Notice is hereby given that an ordinary meeting of the Horowhenua District Council will be held on:

**Date:** Wednesday 30 August 2023  
**Time:** 1:00pm  
**Meeting Room:** Council Chambers  
**Venue:** 126-148 Oxford St  
Levin

<b>ITEM</b>	<b>TABLE OF CONTENTS</b>	<b>PAGE</b>
<b>7.1</b>	<b>Horowhenua District Draft Speed Management Plan: Public Engagement Review and Endorsement</b>	
A.	Appendix A Option A Recommended	3
B.	Appendix B Option B Minimum	13
C.	Appendix C Option C Maximum	23
D.	Appendix D Speed Management Plan 2024 - 2034 Feedback - REDACTED - ALL SUBMISSIONS	37
E.	Appendix E: Confirming Sign Posted Speed Limits	263

Figure 7: Pinch point at Carthew Tce roundabout

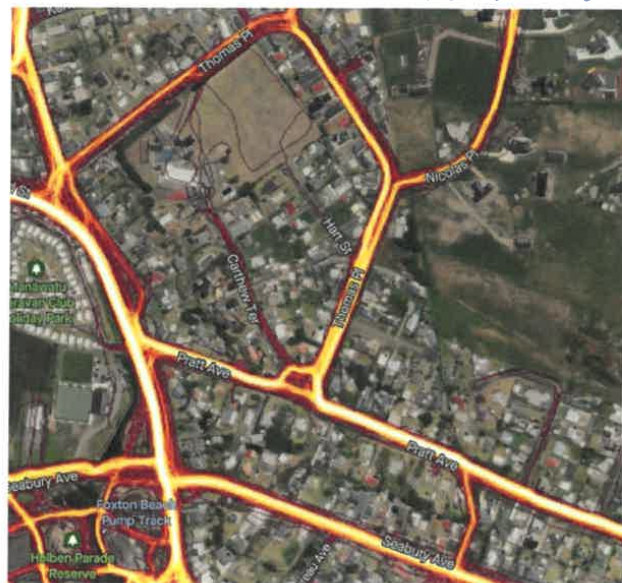
Council has proposed a 30km speed restriction on Carthew Terrace. Foxton Beach School supports this change; however we believe the speed reduction should be **extended to include Pratt Ave** from the Carthew Tce roundabout to the pedestrian walkway between 32-34 Pratt Ave that connects to Seabury Ave. This is due to:

- The large macrocarpa hedge on the Carthew roundabout corner creates a pinch point for pedestrian movement, and reduces driver visibility when exiting the roundabout onto Pratt Ave. While Council has taken measures to improve issues around the hedge, it continues to be a problem for vulnerable road users (Figure 7)

- Near misses with vulnerable road users occur along this section, possibly as much as on a monthly basis.
- Pratt Ave is a high use pedestrian route for Foxton Beach as shown on Strava heatmap (Figure 8).

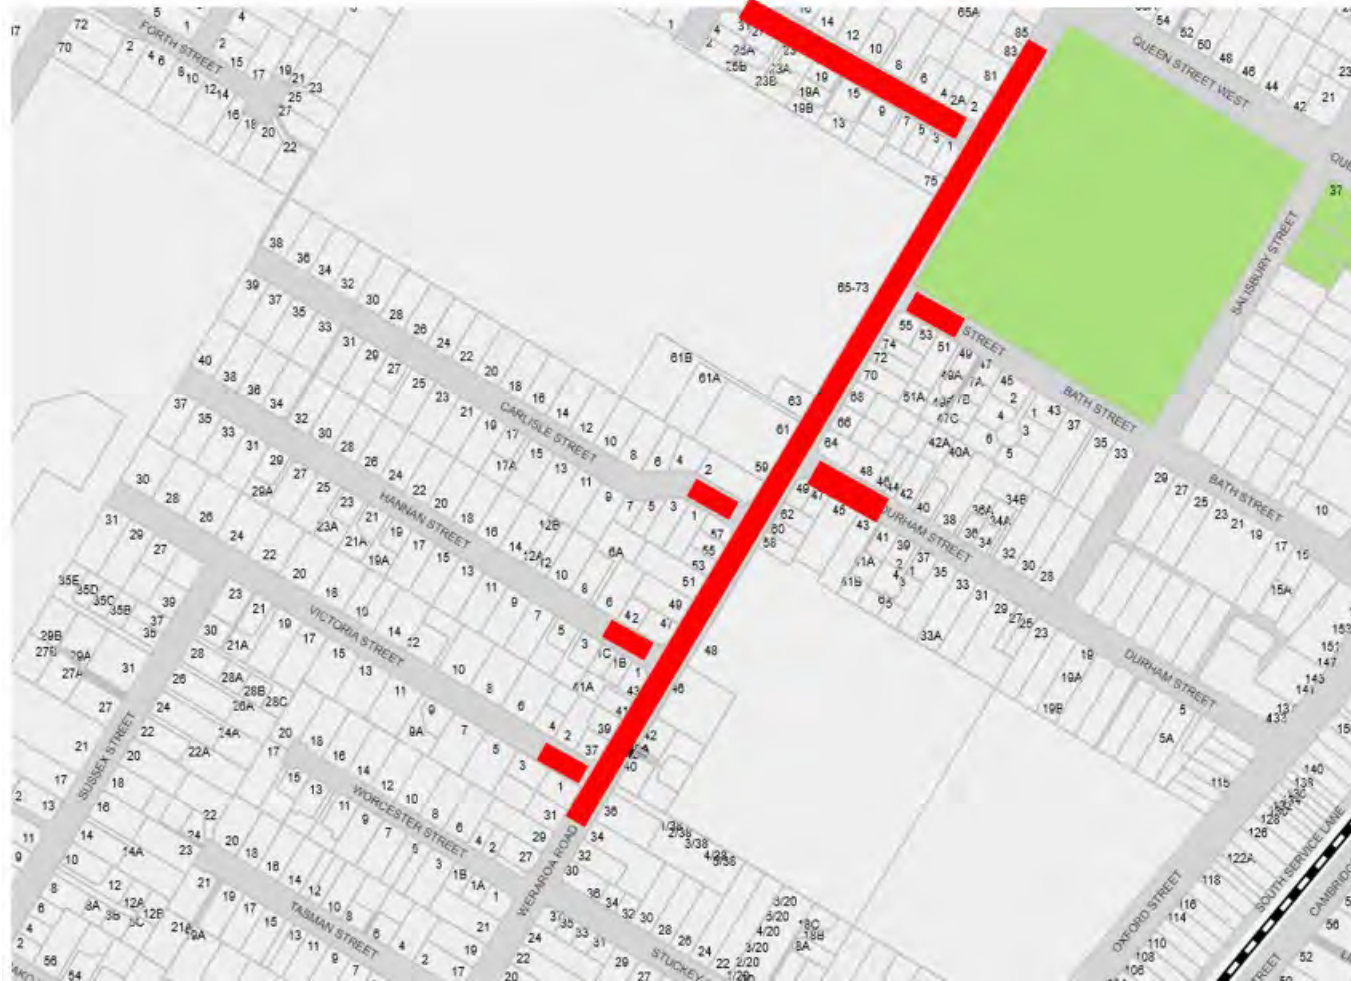
2. Change to map : Variable 30km/h speed limit should only apply from 31 Werarua Road to 83 Werarua Road; from Werarua Road to 51 Bath Street (David Court is private road), from Werarua Road to 43 Durham Street (Cumberland Court is private road)

4. Attached revised map showing suggested variable 30km/h speed limit
